Board of Aldermen Request for Action

AGENDA ITEM: Resolution 1227, Site Plan Approval – 14781 North Fairview Drive

STAFF REPORT
May 4, 2023
Site Plan Review for Parcel Id # 05-917-00-07-008.00

NEW BUILDING FOR
FAIRVIEW NORTH SHOPPING CENTER
 SMITHVILLE, MO

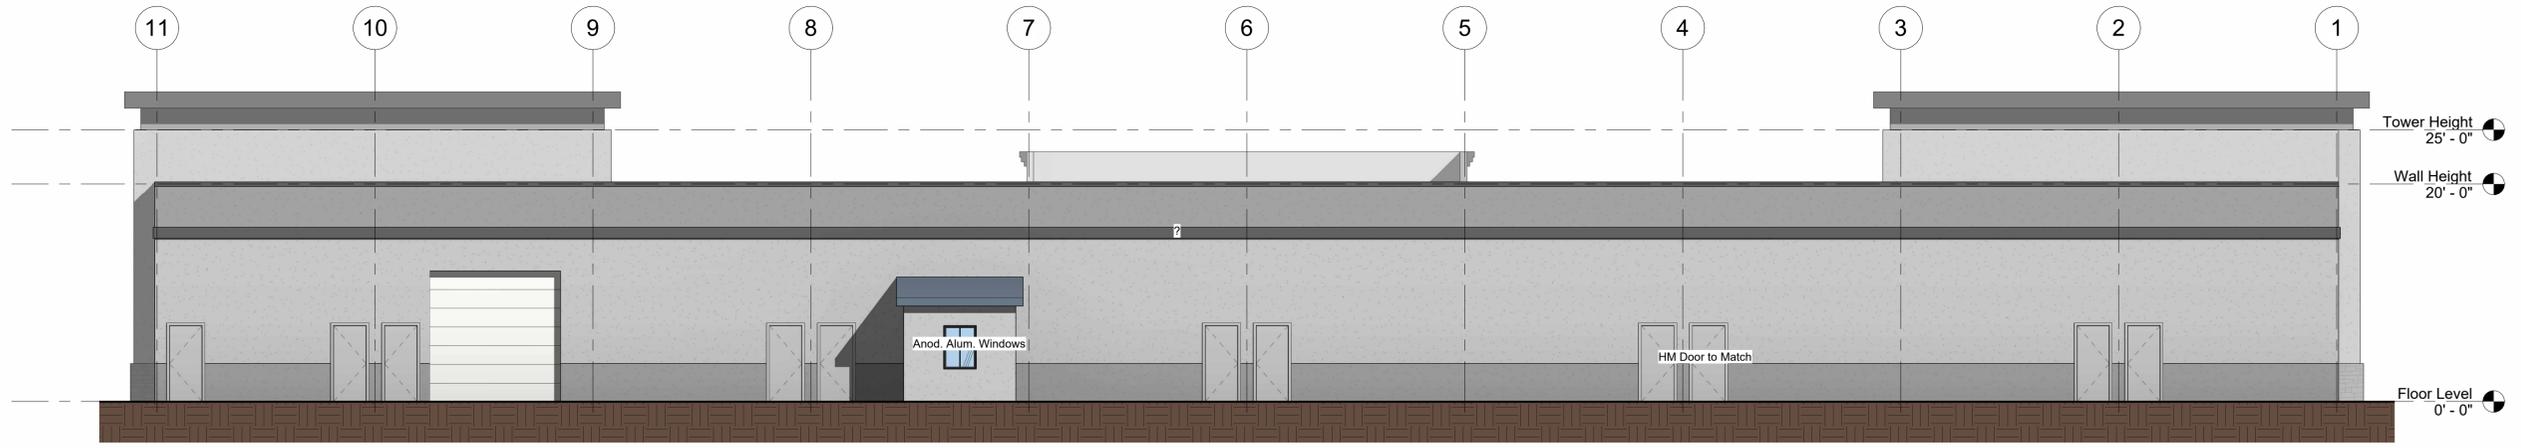
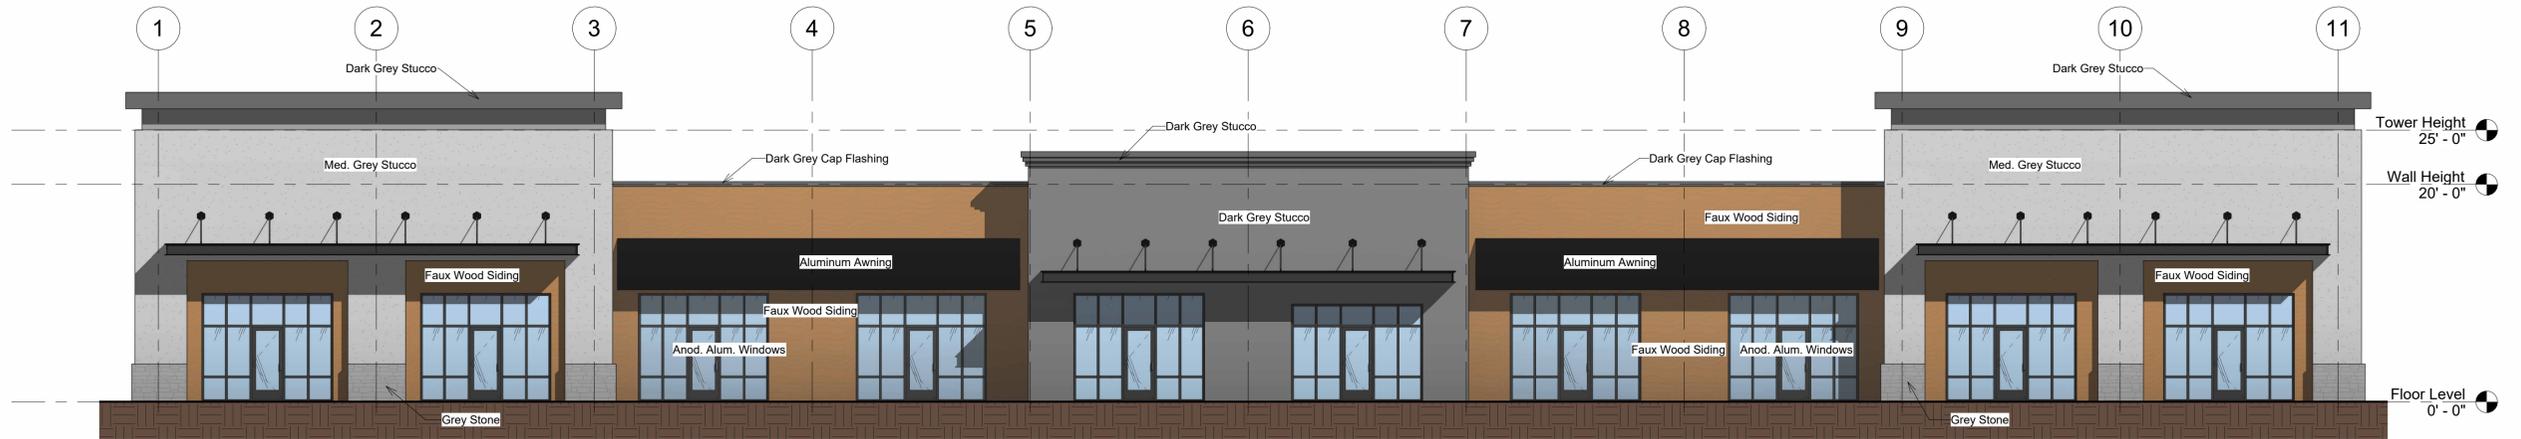
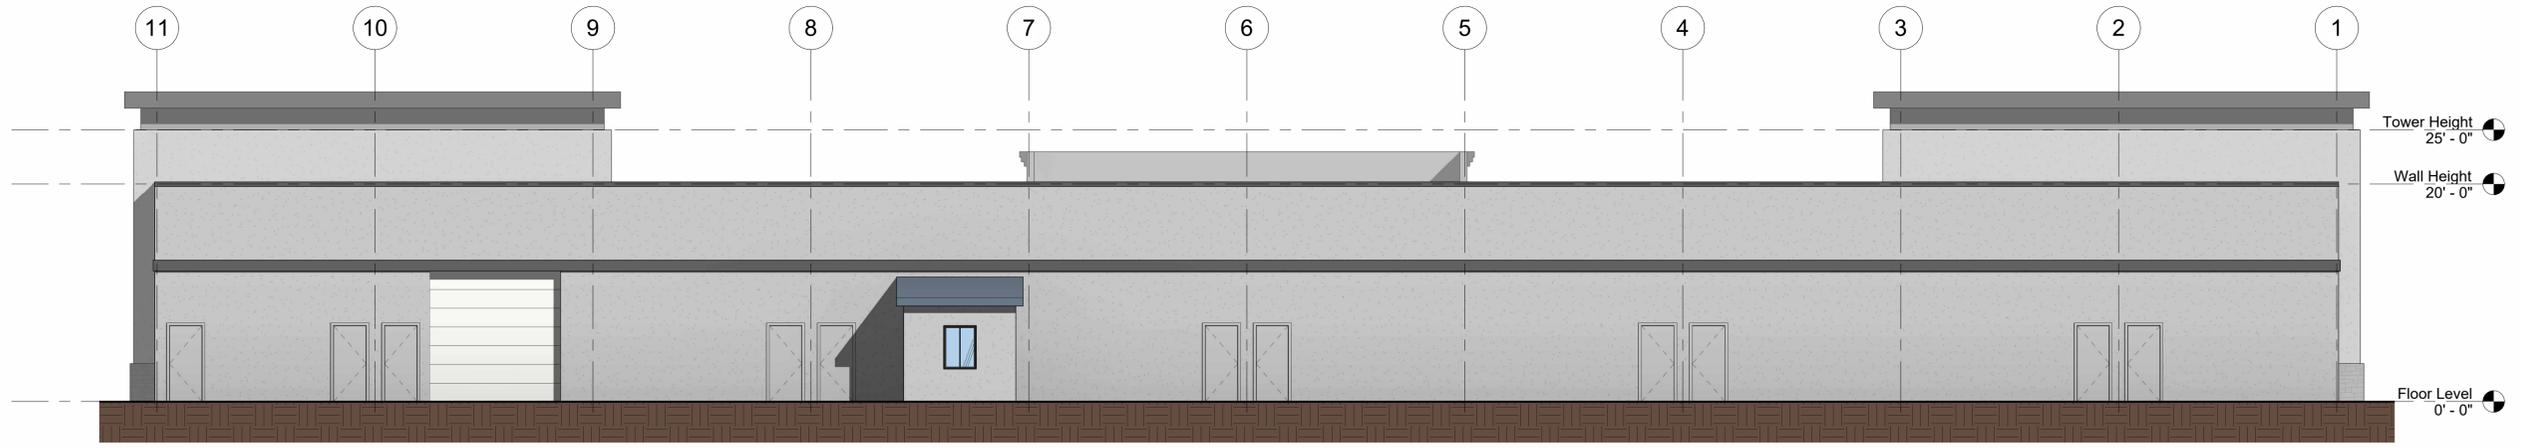
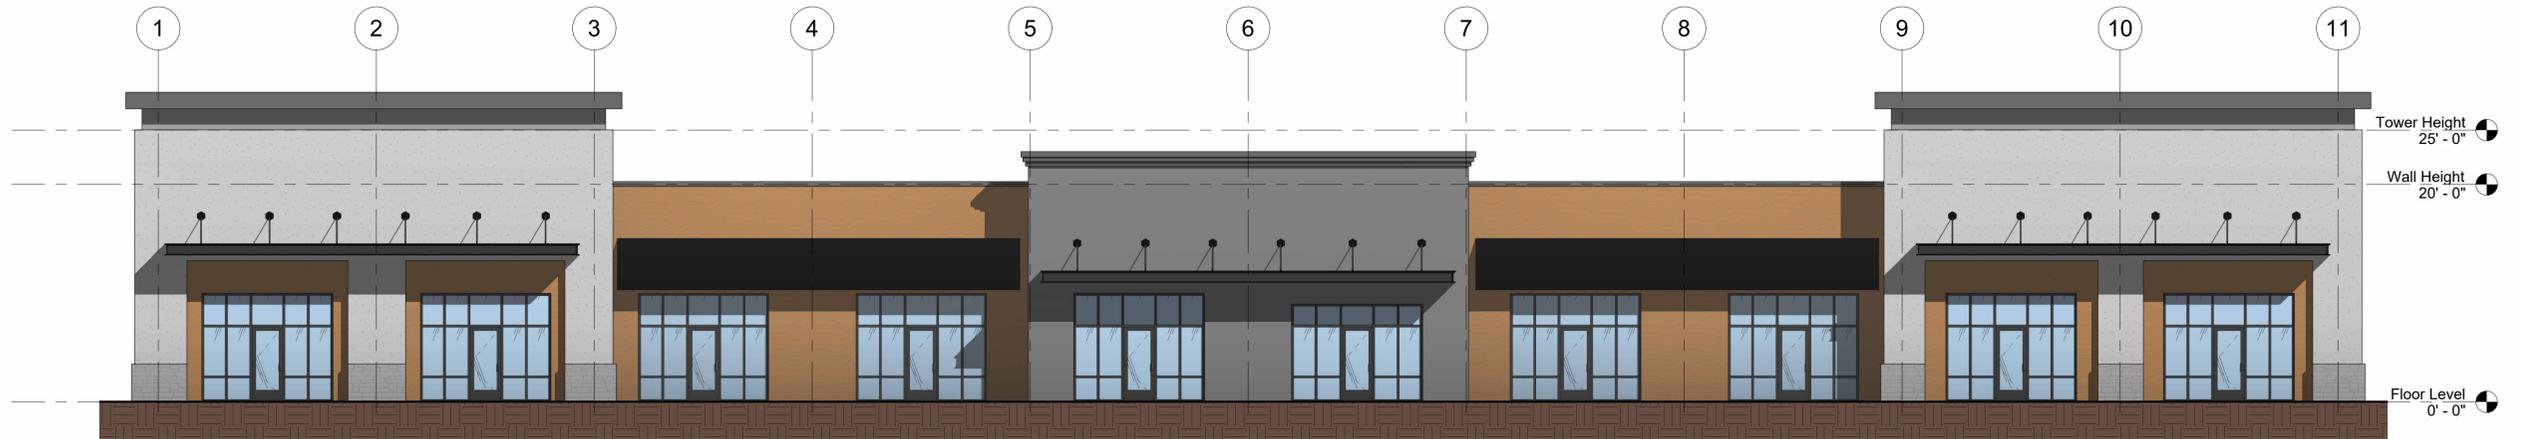
Staff recommends APPROVAL of the proposed Site Plan conditioned upon including the changes to the plans for the rear and partial sides to create defined top, middle and bottom sections in accordance with the existing portions of the sides that meet the standards.
